December 21, 2015

Final Development Plan

#201509280073

Farm Banks Way, Grove City

DATE 12-11-2015 SITE PLAN

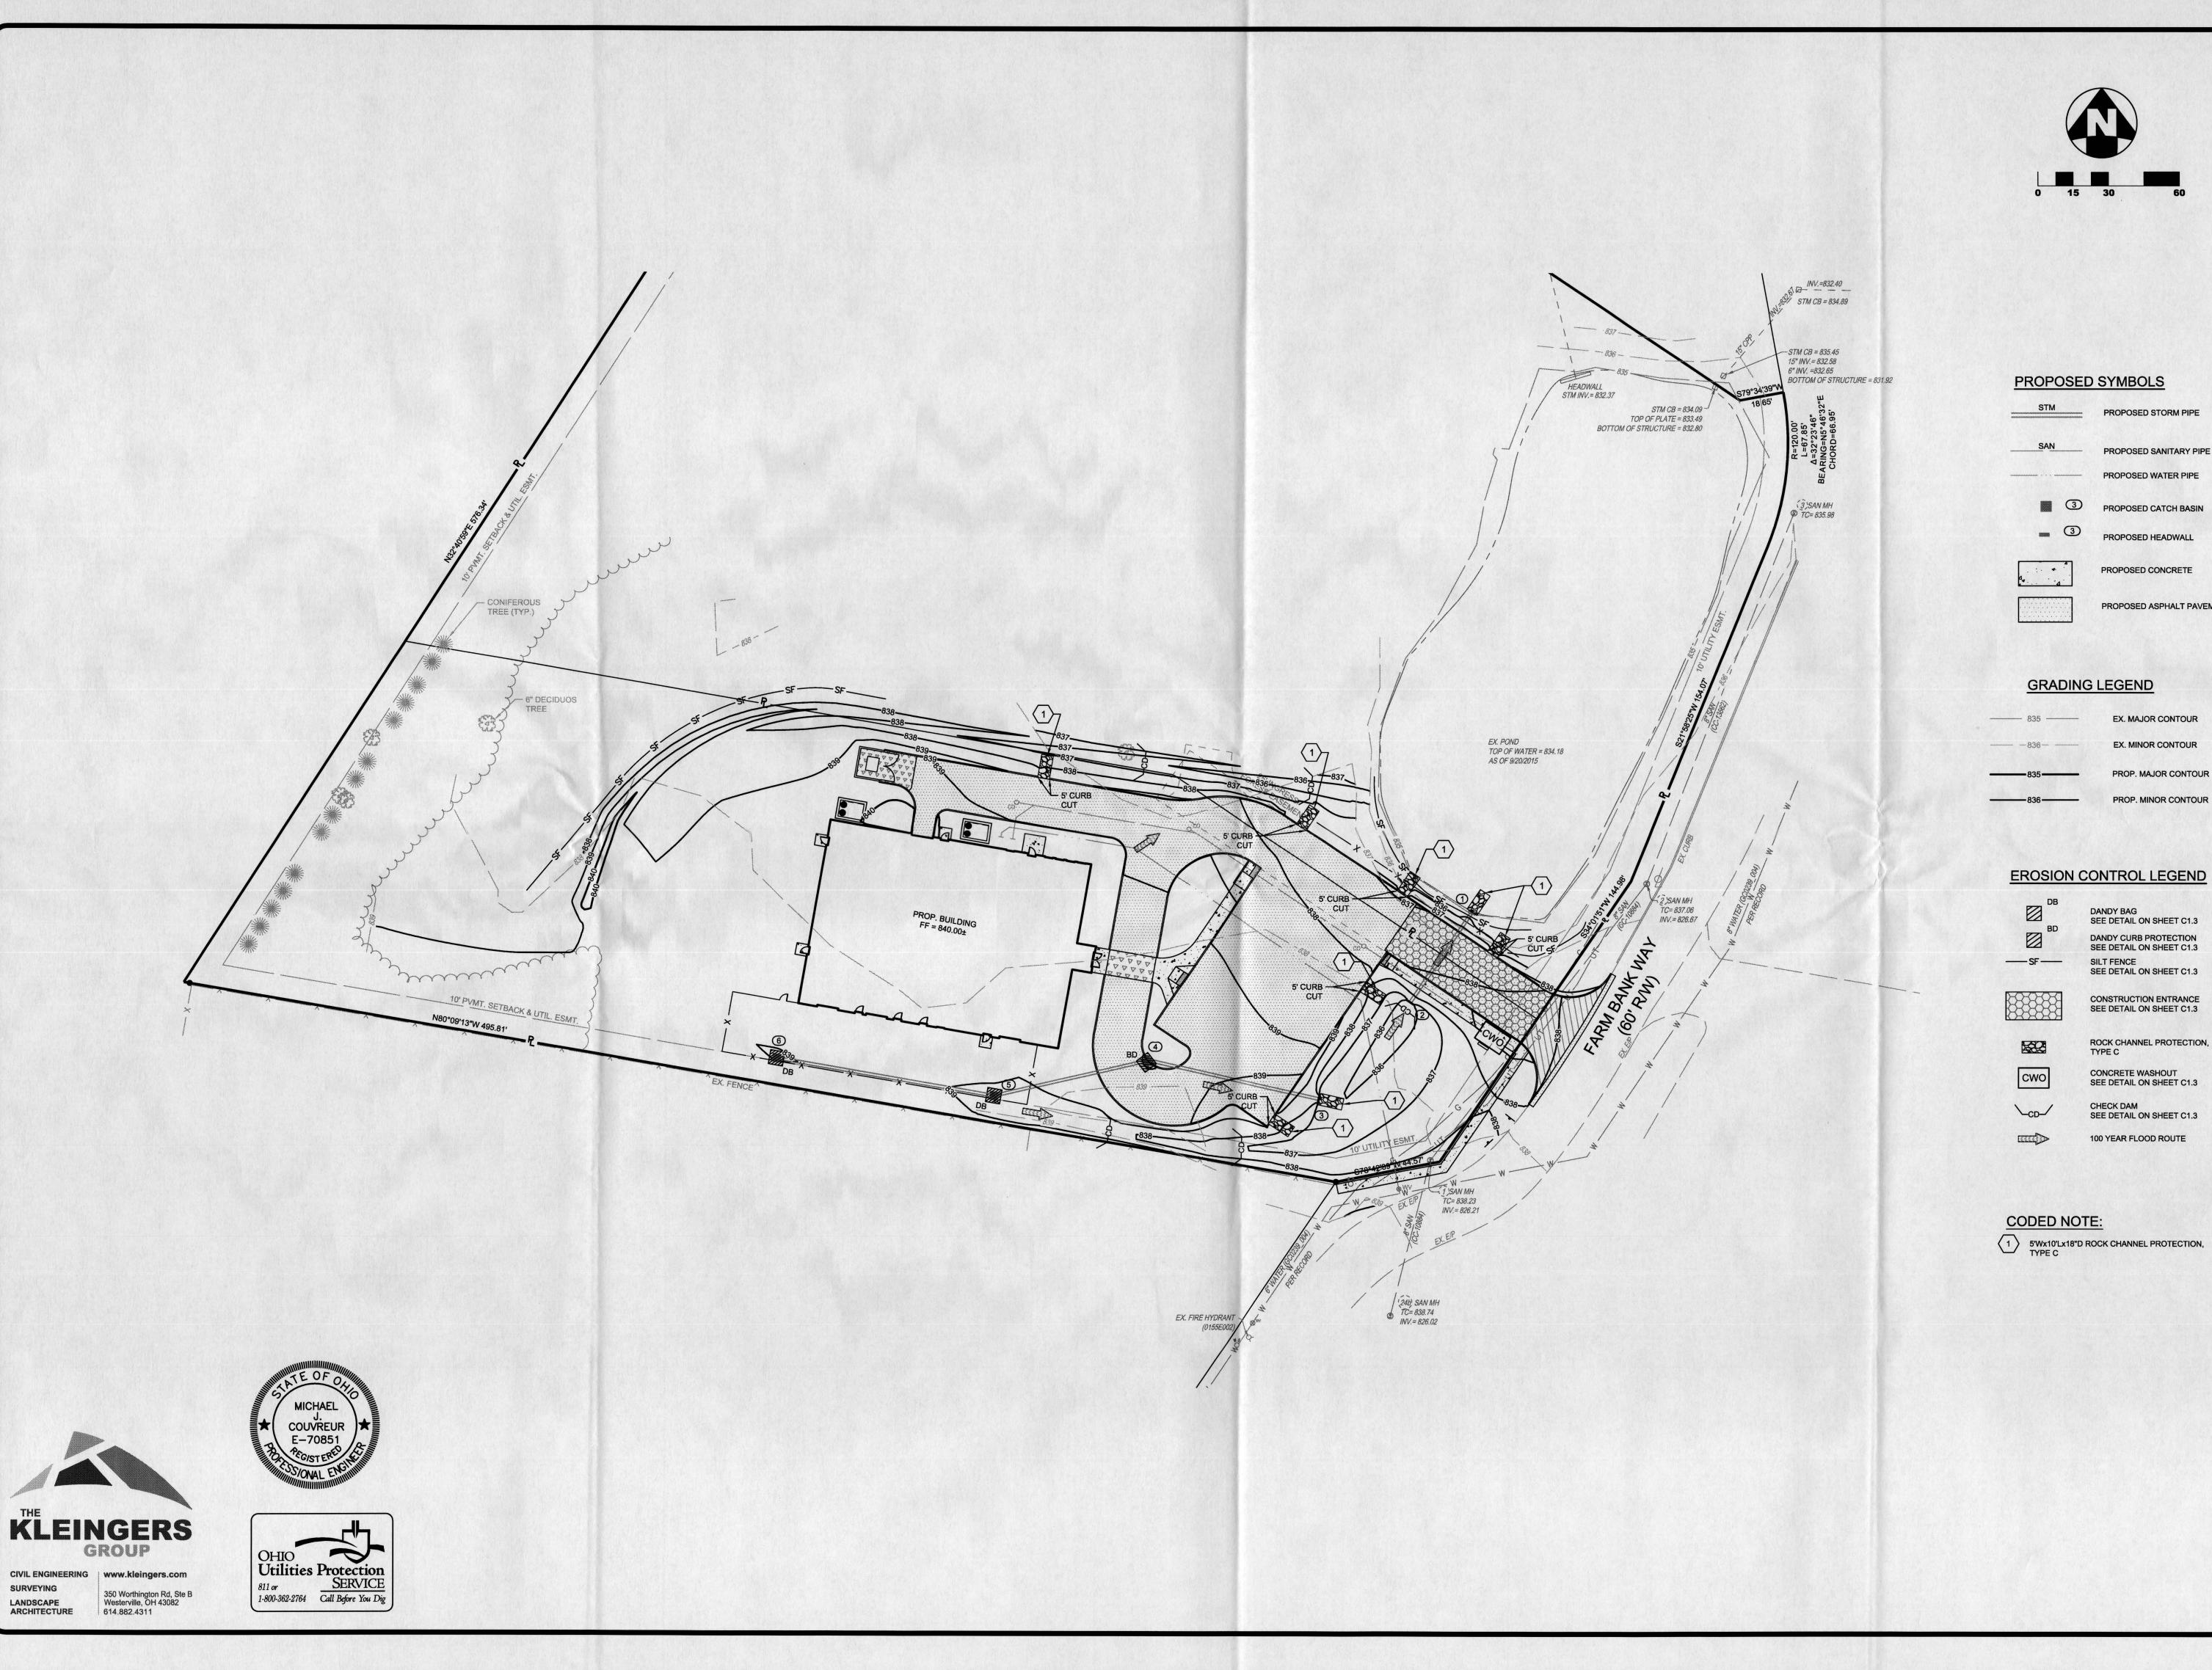
The zoning of adjacent parcels should be added to plans.

3. The proposed sidewalk along Farm Bank Way should connect to the sidewalk along the east side of the building. Response: A sidewalk connecting the public walk to the front entry has been added to the site plan.

15. Building dimensions are not shown on plans.

Response: This has been added to sheet C1.0

Response: Building dimensions have been added to sheet C1.0.

DUMPSTER ENCLOSURE ELEVATION

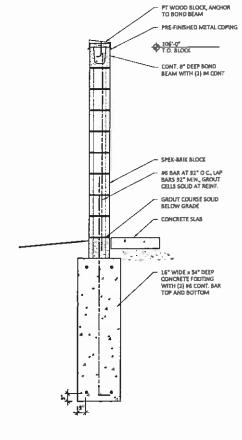
10. Details should be submitted for the proposed dumpster enclosure. The enclosure should be finished in materials to match the primary structure and should have stained wood gates.

Response: Please refer to enclosed dumpster enclosure details on sheet SP-2.

FENCE ELEVATION

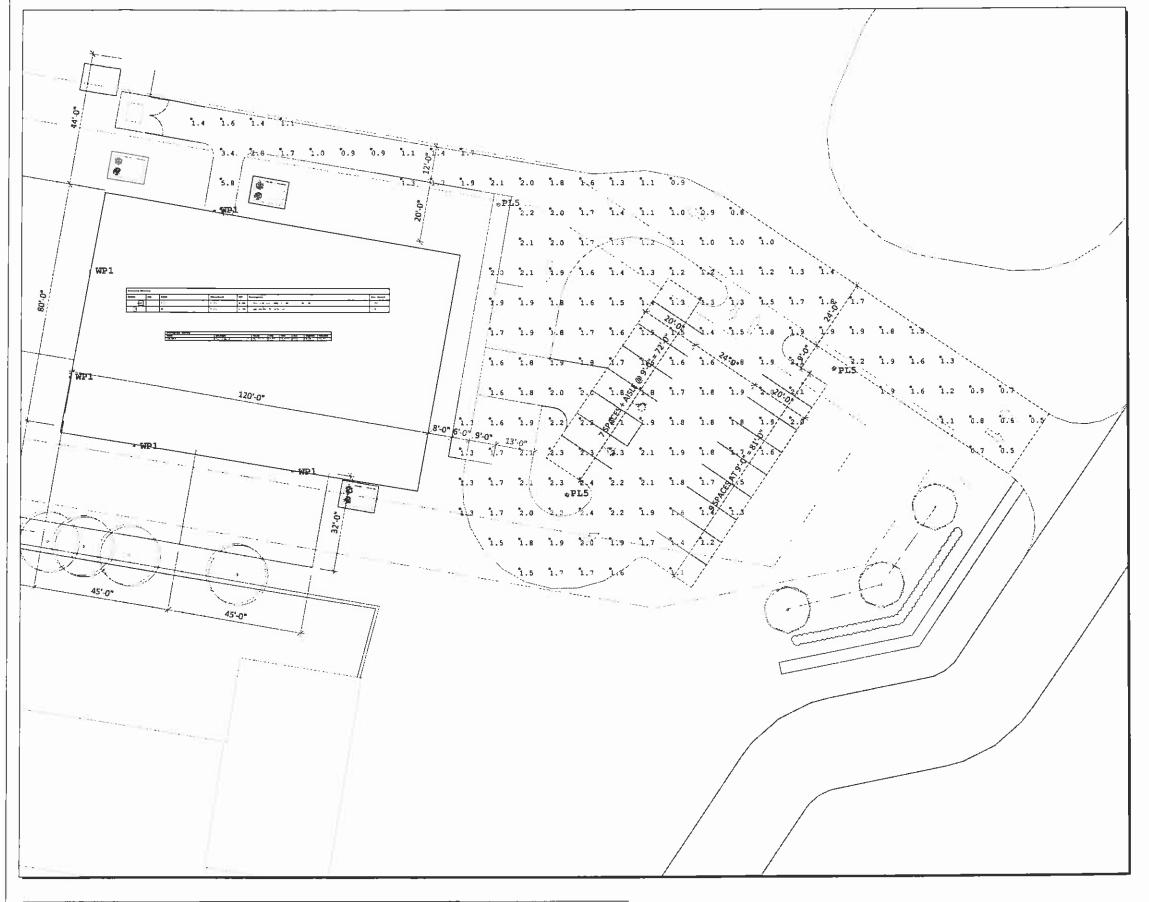
9. Details should be submitted for the proposed 8' fence.

Response: Please refer to enclosed fence details on sheet SP-2.
